Technical Service Information

THM 4T40-E TROUBLE CODE P1887 OR P0742

THM 4T40-E OIL PUMP ASSEMBLY

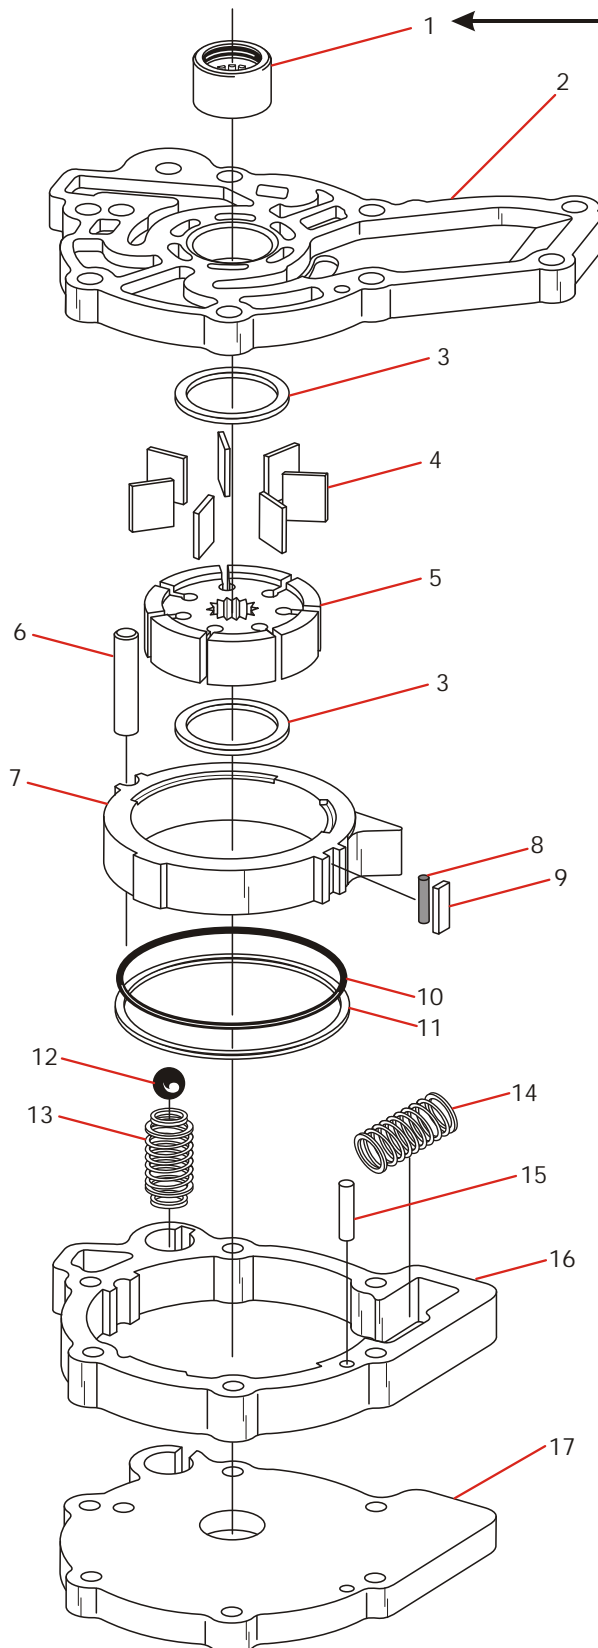
COMPLAINT: Before and/or after rebuild, the vehicle illuminates the check engine lamp and stores code P1887 or P0742 in memory. Once the code is stored, TCC will be inhibited and maximum line pressure will be set creating harsh engagements and shifts.
P1887 Code Definition; TCC Release Switch Circuit Malfunction.
P0742 Code Definition; TCC Locked On.

CAUSE: This is usually created by a leak of TCC release oil through the needle bearing and seal assembly located in the oil pump, as shown in Figure 1.

CORRECTION: This needle bearing and seal assembly is now available under TranStar part number 67922B. In some instances, because of the bearing failure, the entire pump assembly will have to be replaced and is available under OEM part number 24208987.

This Needle Bearing and Seal Assembly has been such a high failure item that ATSG recommends the needle bearing and seal assembly be replaced on every rebuild.

*This Needle Bearing and Seal Assembly
Is Now Available Under TRANSTAR
Part No. 67922B*
